Application by Mallard Pass Solar Farm Limited for an Order Granting Development Consent for Mallard Pass Solar Project- EN010127

Submission by John Hughes: ID ref: 20036141

Deadline 1 Written Submission on OFH 1 meeting 17<sup>th</sup> May 2022

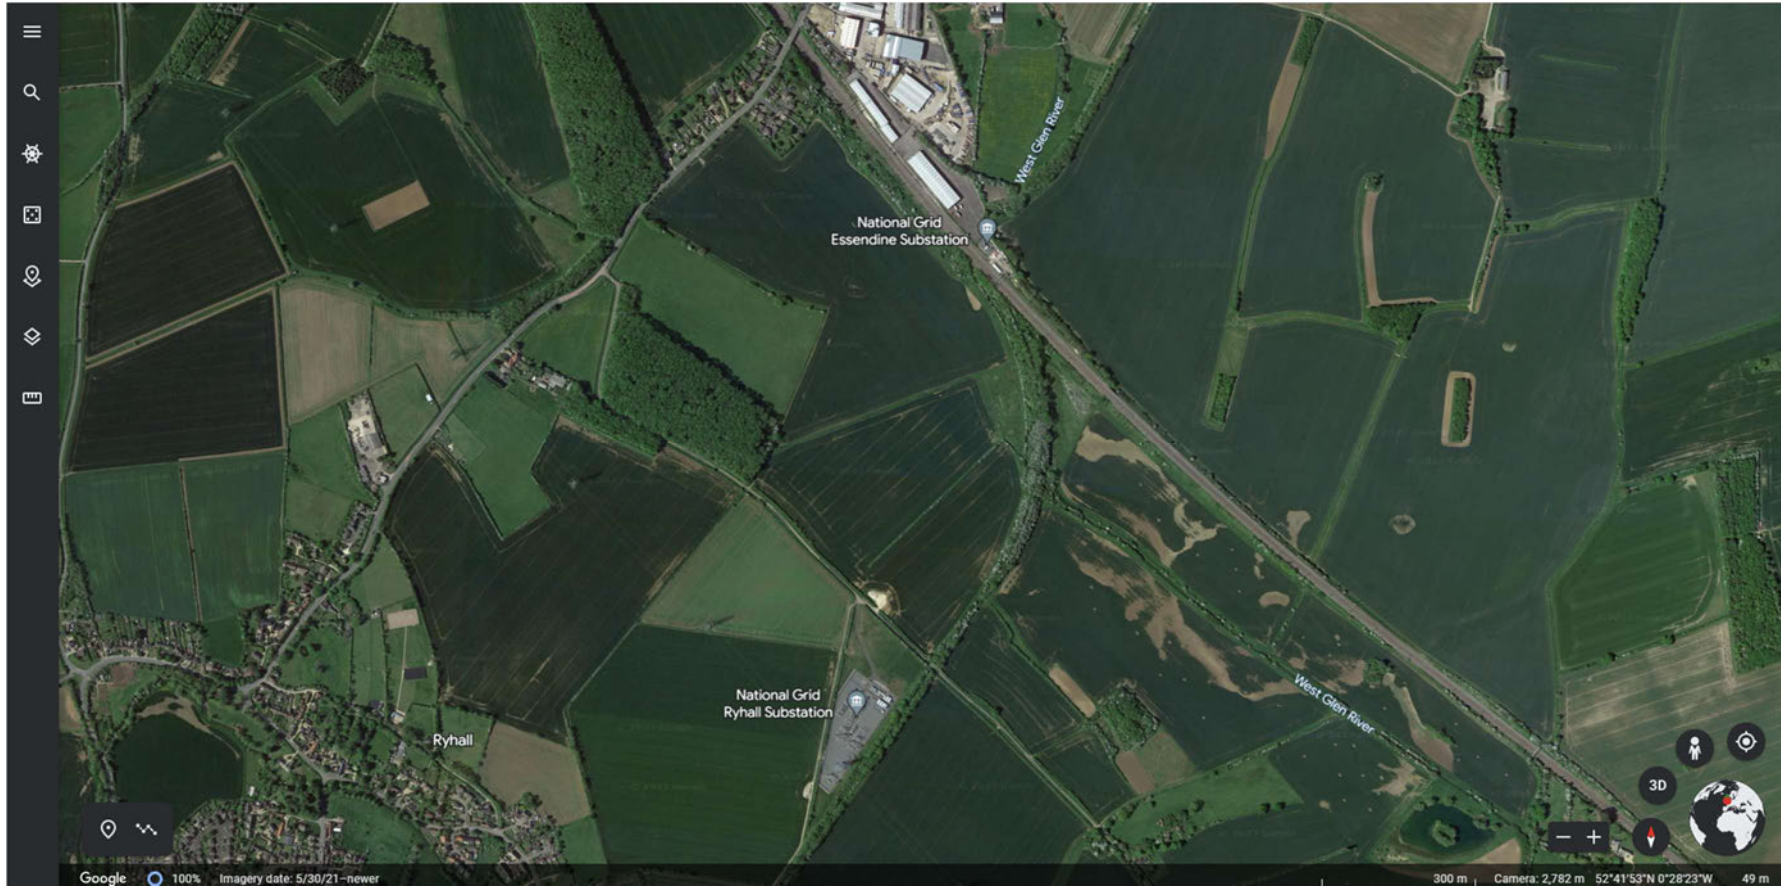
Q. Why in the 'Residential Visual Amenity Assessment' Table 1 in relation to [REDACTED] and [REDACTED] is the Magnitude of Change 'Low/Negligible and the Significance of Effect 'Slight' considering based on current plans both the new substation field 19 and PV arrays in field 18 will highly visible

a) Field 26 falls away from [REDACTED] and [REDACTED] from 40m down to 23m (Google Earth)

b) Field 18 rises up from 23m to 39m with its boundary between field 26 & 19 making any PV arrays sited in this field highly visible, mitigated planting would have little effect due to the elevation of 16m is between boundary of Field 26 and 18 and does not take into account the elevation rise in the field.

c). Field 19 the current hardcore location is 36m above sea level, the proposed substation at 13m high would take the elevation to 49m and no mitigated planting is considered between field 18 and 19

Field 18, No PV arrays should be built in this field it should either be left arable or planted as meadow

Field 19, No substation should be built in this field, we've already had 'National Grid Essendine Substation' and 'National Grid Ryhall Substations' built as well the expansion of storage buildings in the Industrial estate.

Representative Viewpoint 7 (Centre) - Public footpath Uffi/5/1 to east of Newstead Lane and Cobbs Nook Farm

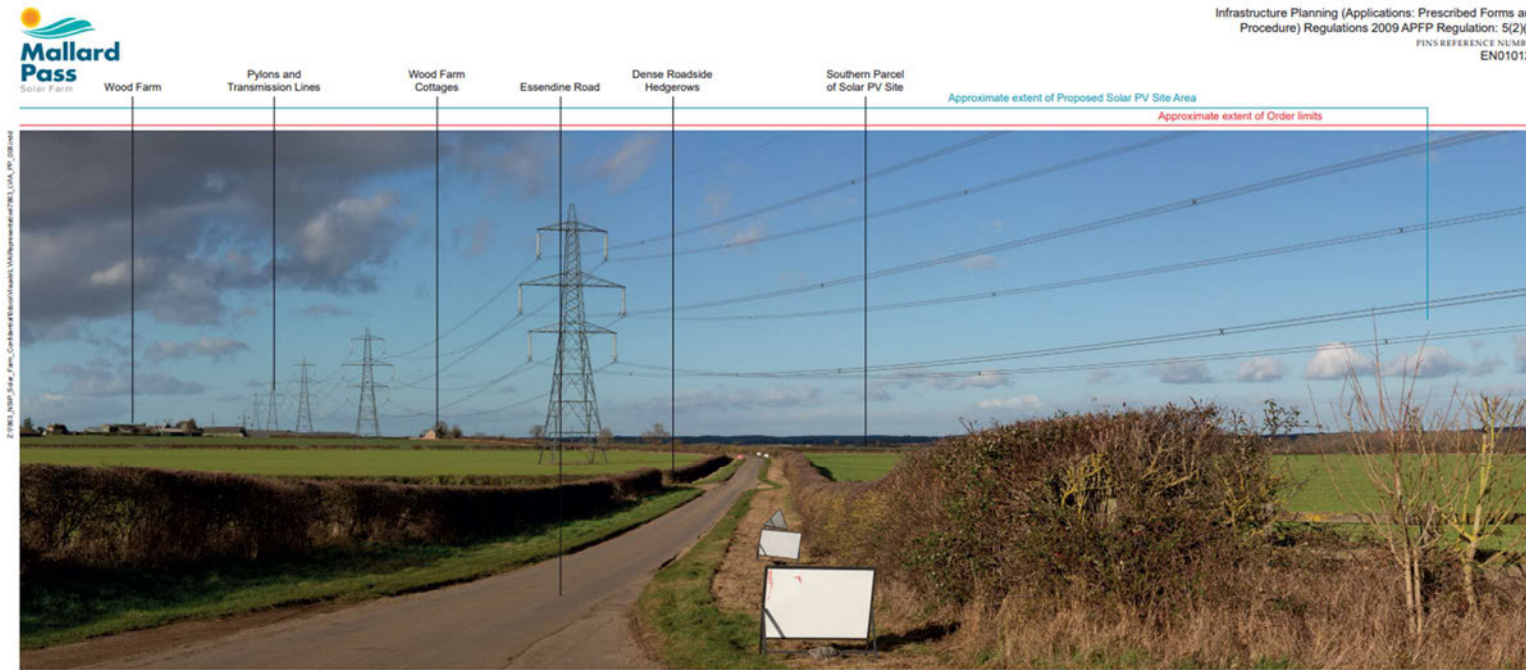
These photos are more representative of the current views and better located than the Stage 2 photo which were at a lower point.

Photomontages should be presented so examiners can appreciate the effect the mitigated planting and PV arrays will have to walkers of this footpath.

Representative Viewpoint 9 (Left) - Essendine Road near The Freewards

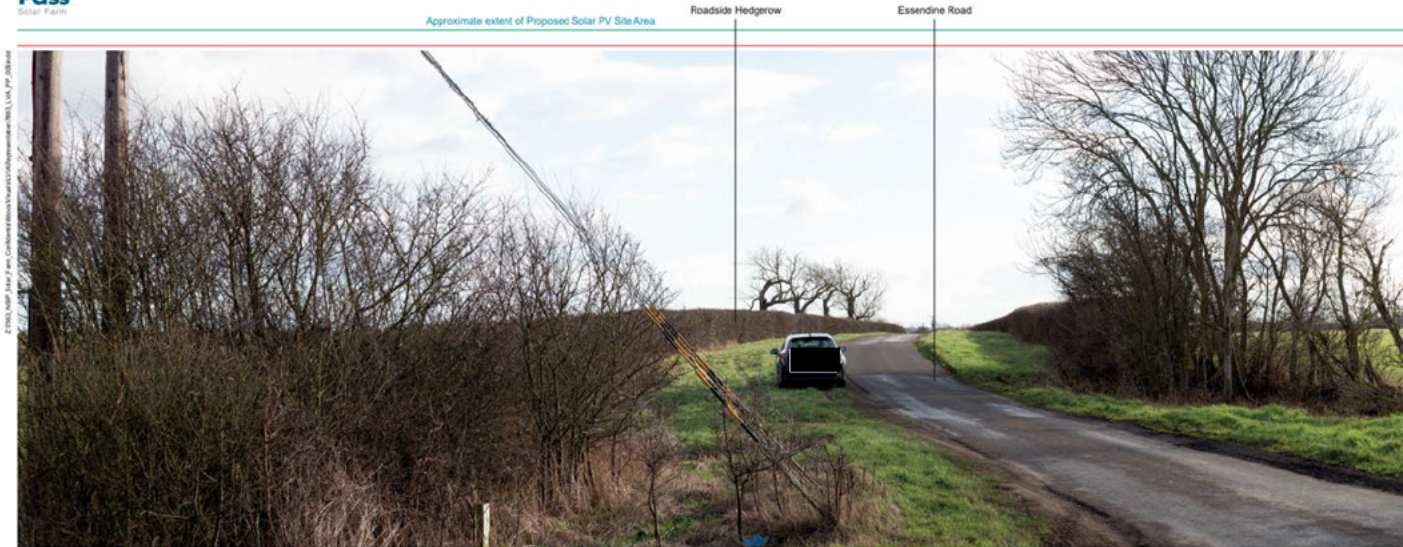
The VP is representative of motorist and the closest VP to the proposed new substation and taken at a low point in the road.

Note Essendine Industrial Estate on the left but no indication of the location of the new substation in either photo because it is so far away this site.

Note the distant fields on the opposite side of the ECML and how they reach the horizon these will filled with PV array.

### Viewpoint 2 Footpath (see Figure 3 of Appendix A)

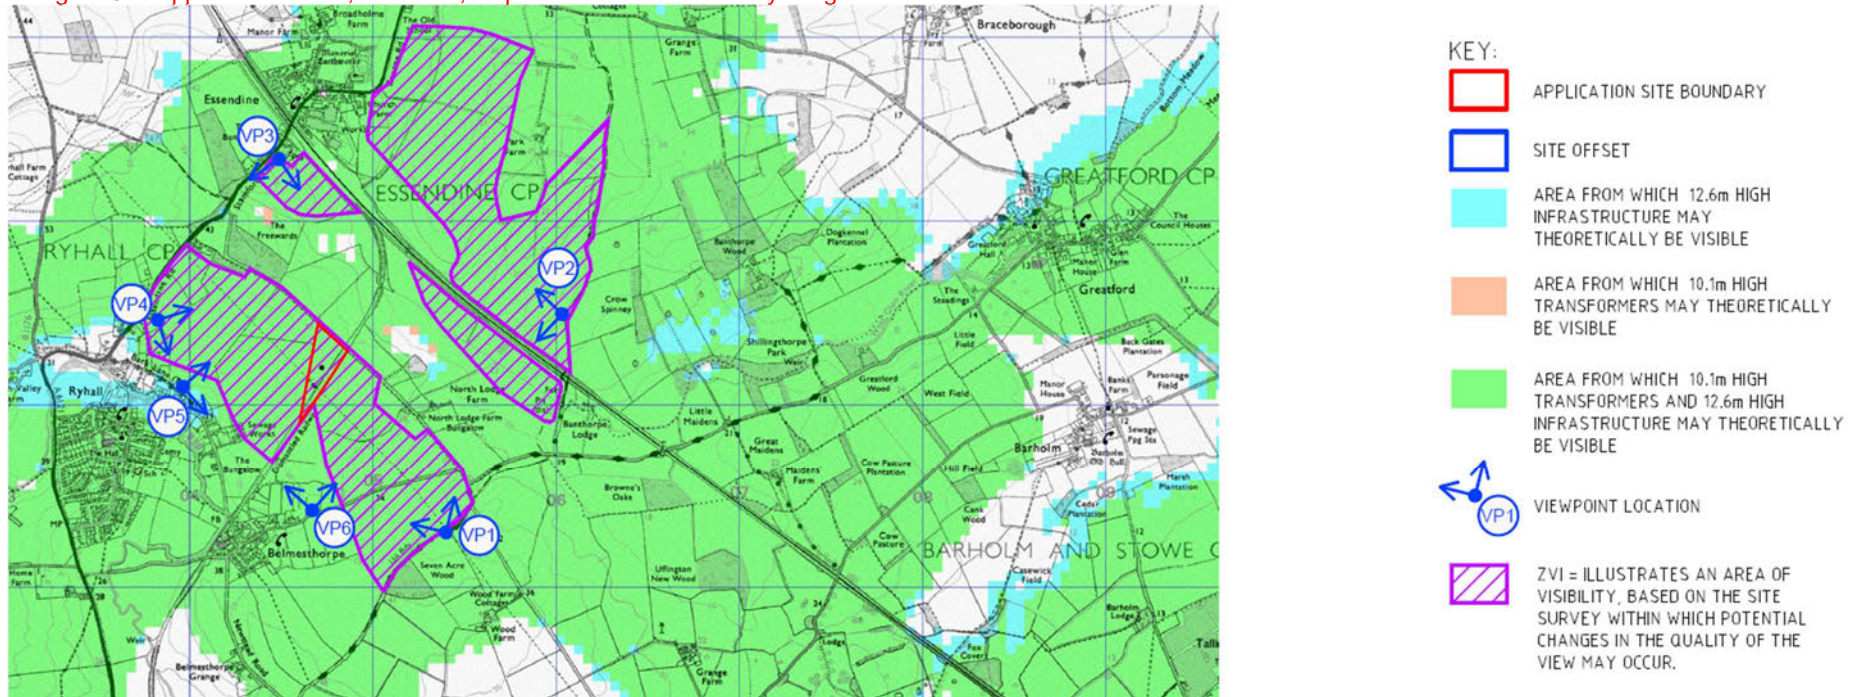
During operation most of the compound and associated industrial features would be screened in summer by the vegetation along the dismantled railway on the south side of the site. However the upper sections of **the taller equipment within the compound may be discernable in winter when the tree canopies are bare**. Overall the development would be similar to the existing situation and where any of the additional features with the compound are visible they would be over a very narrow view angle and in a wider 180 degree view typically influenced by the line of existing pylons.
